LAND USE APPLICATION COMPLETENESS REVIEW

Second Review Comments

Subject Property: 1105 Front Street NE

Reference Nos.: 24-106451-PLN (Class 3 Site Plan Review, Tentative Subdivision Plan, Class 1 & 2 Adjustment, Class 2 Driveway Approach Permit)

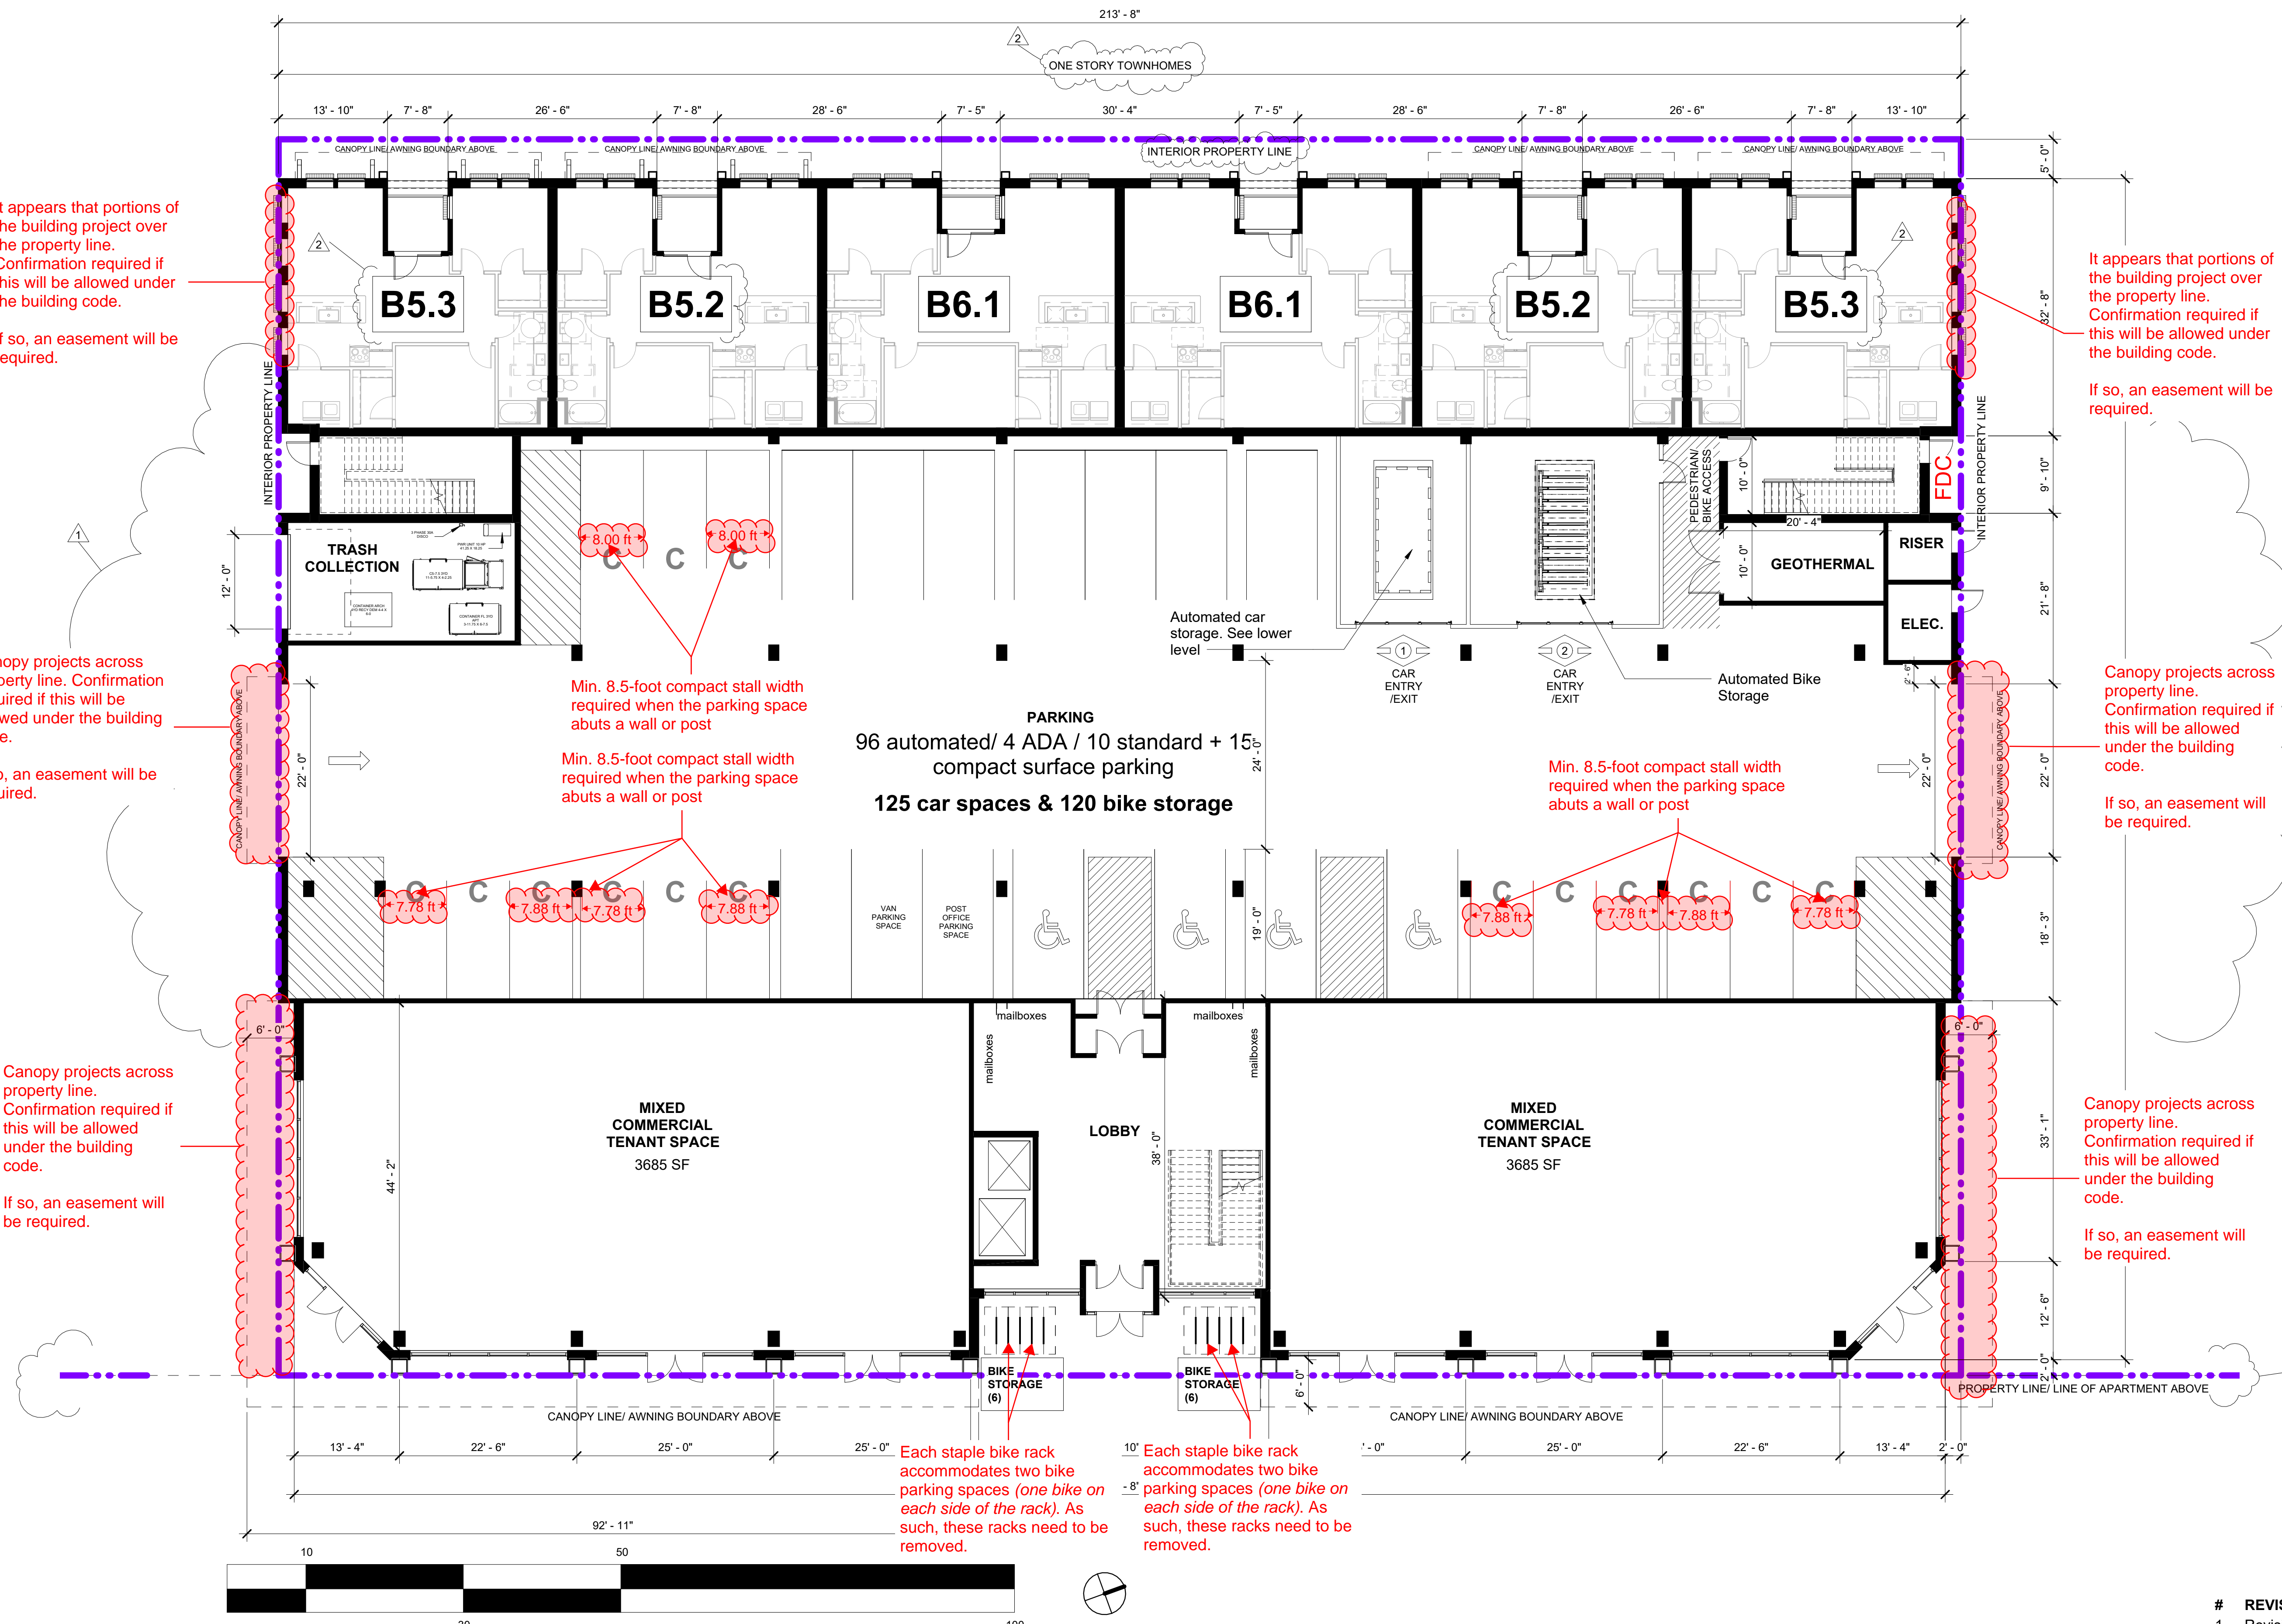
It appears that portions of the building project over the property line. Confirmation required if this will be allowed under the building code.
If so, an easement will be required.

It appears that portions of the building project over the property line. Confirmation required if this will be allowed under the building code.
If so, an easement will be required.

Canopy projects across property line. Confirmation required if this will be allowed under the building code.
If so, an easement will be required.

Canopy projects across property line. Confirmation required if this will be allowed under the building code.
If so, an easement will be required.

Canopy projects across property line. Confirmation required if this will be allowed under the building code.
If so, an easement will be required.

Canopy projects across property line. Confirmation required if this will be allowed under the building code.
If so, an easement will be required.

Min. 8.5-foot compact stall width required when the parking space abuts a wall or post
Min. 8.5-foot compact stall width required when the parking space abuts a wall or post

Min. 8.5-foot compact stall width required when the parking space abuts a wall or post

Each staple bike rack accommodates two bike parking spaces (one bike on each side of the rack). As such, these racks need to be removed.
Each staple bike rack accommodates two bike parking spaces (one bike on each side of the rack). As such, these racks need to be removed.

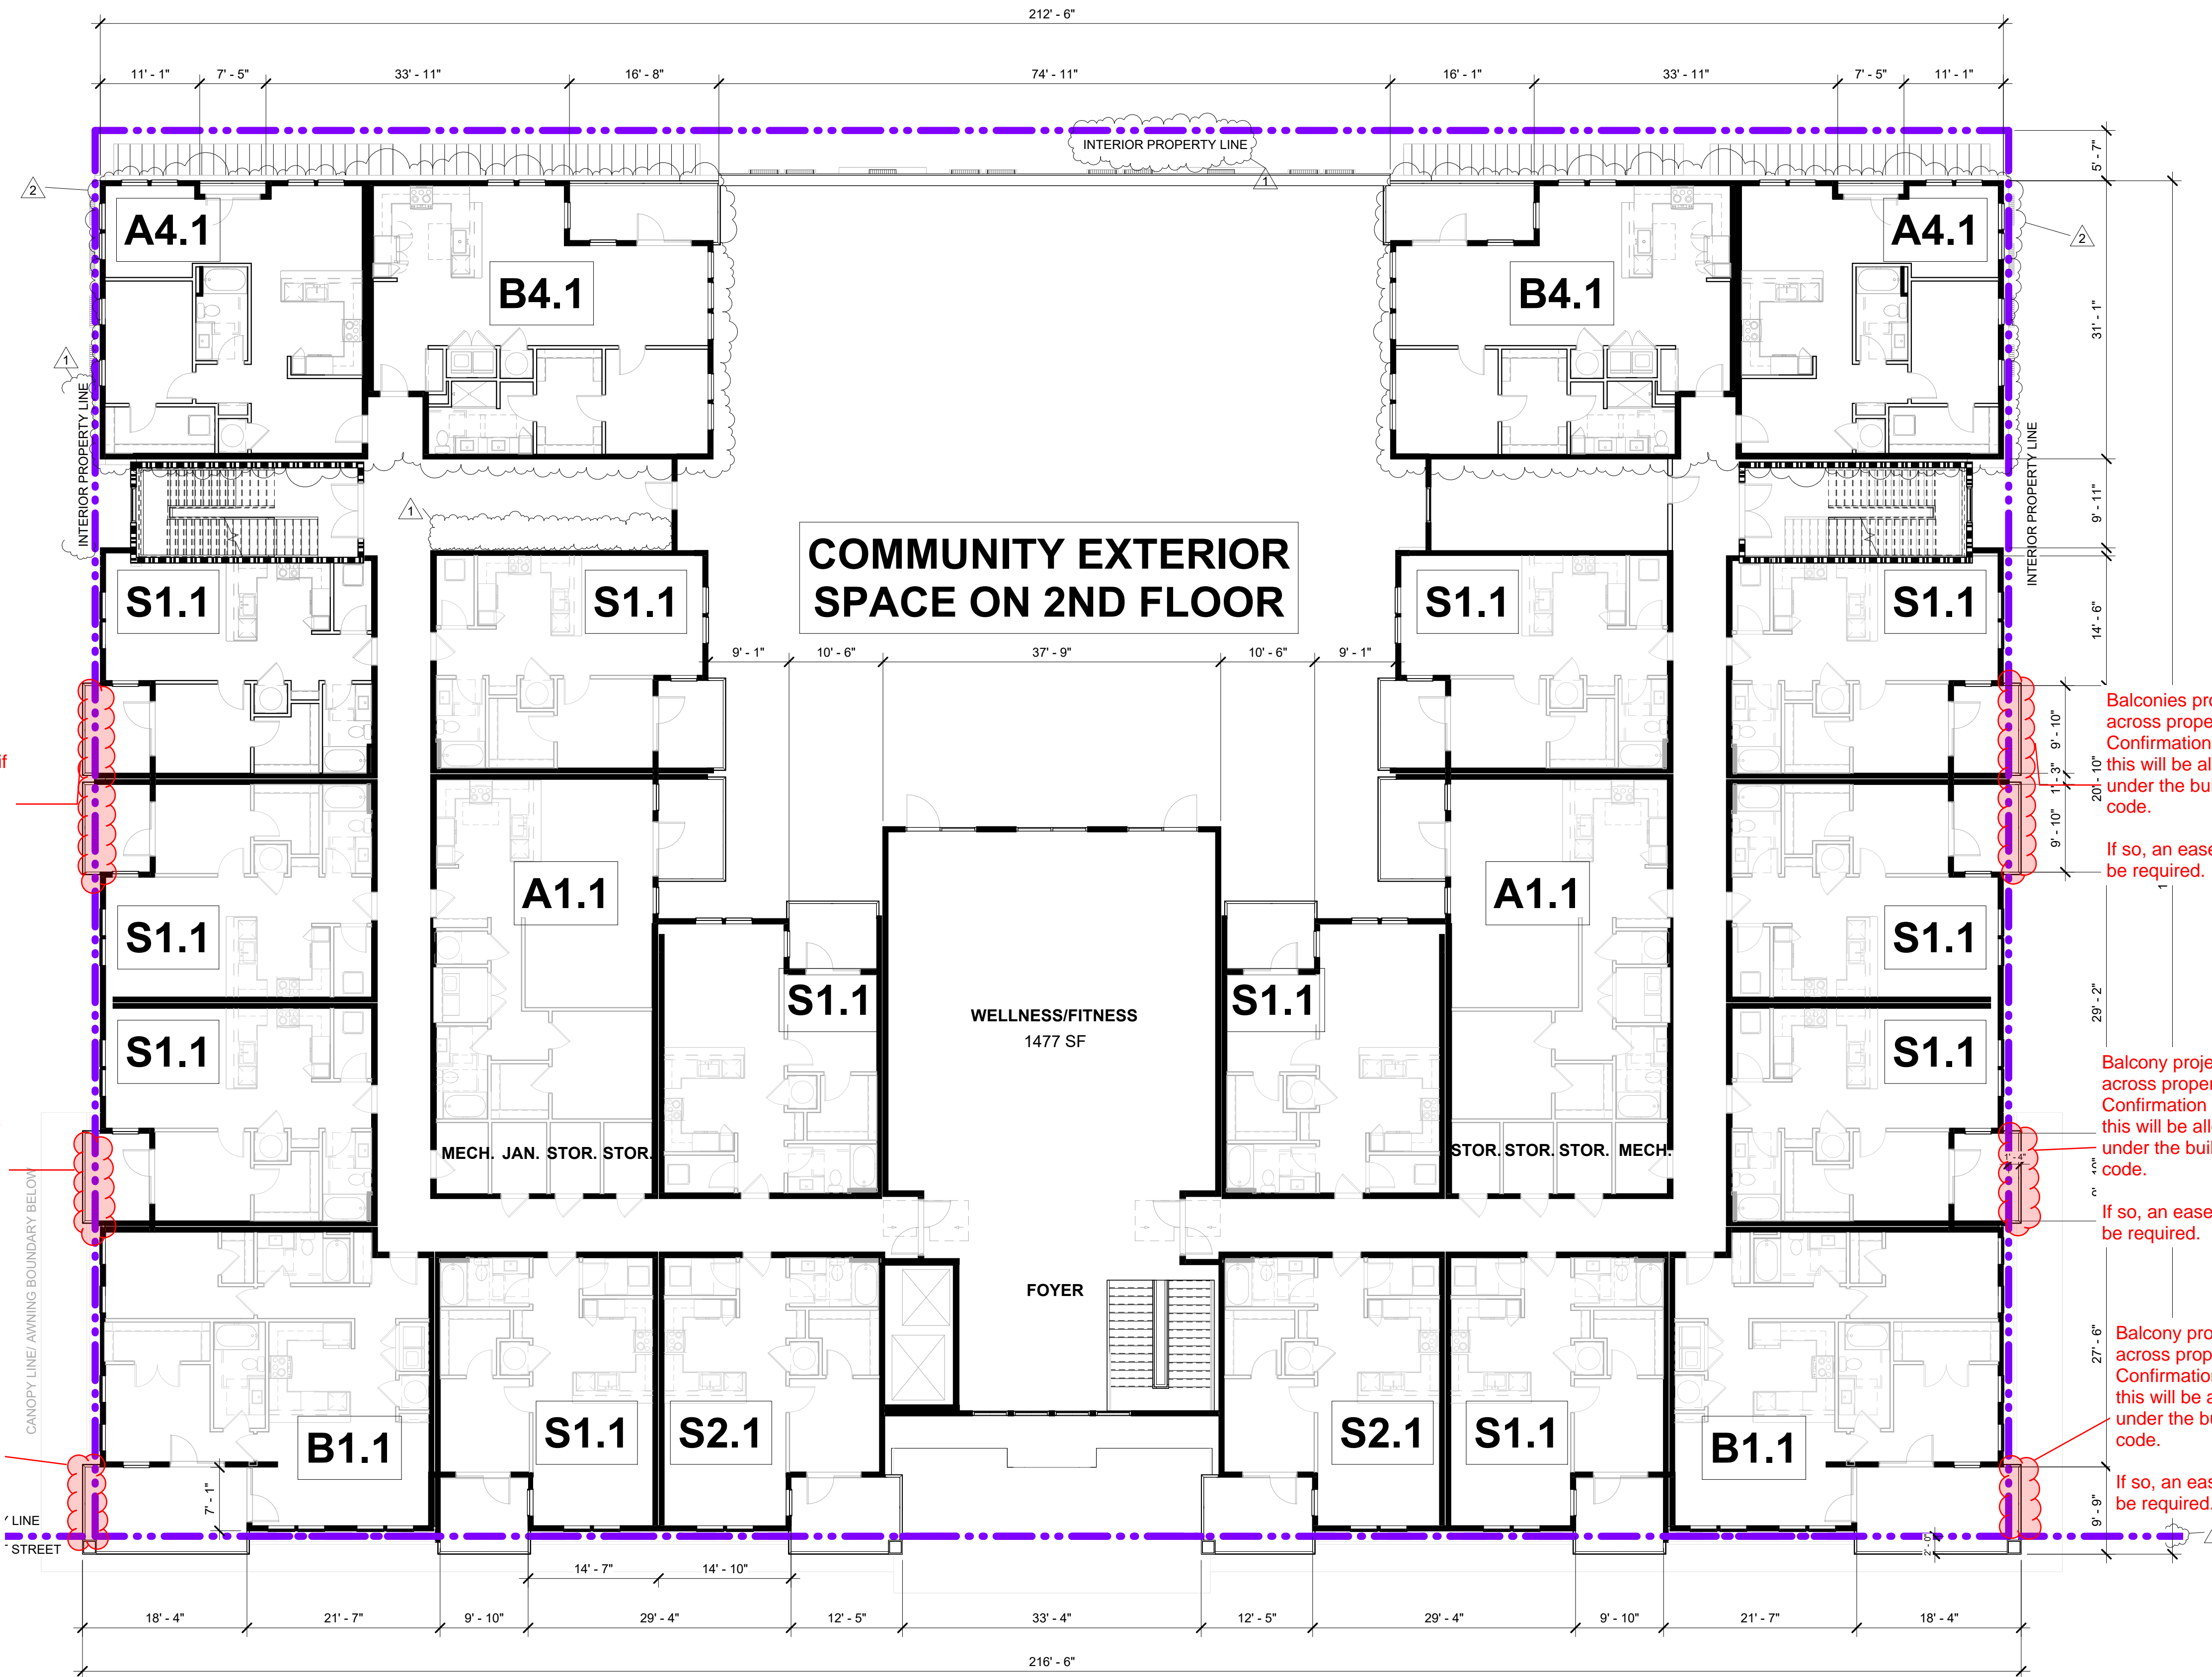
Balconies project across property line. Confirmation required if this will be allowed under the building code.

If so, an easement will be required.

Balcony projects across property line. Confirmation required if this will be allowed under the building code.

If so, an easement will be required.

Balcony projects across property line. Confirmation required if this will be allowed under the building code.

If so, an easement will be required.

Balconies project across property line. Confirmation required if this will be allowed under the building code.

If so, an easement will be required.

Balcony projects across property line. Confirmation required if this will be allowed under the building code.

If so, an easement will be required.

Balcony projects across property line. Confirmation required if this will be allowed under the building code.

If so, an easement will be required.
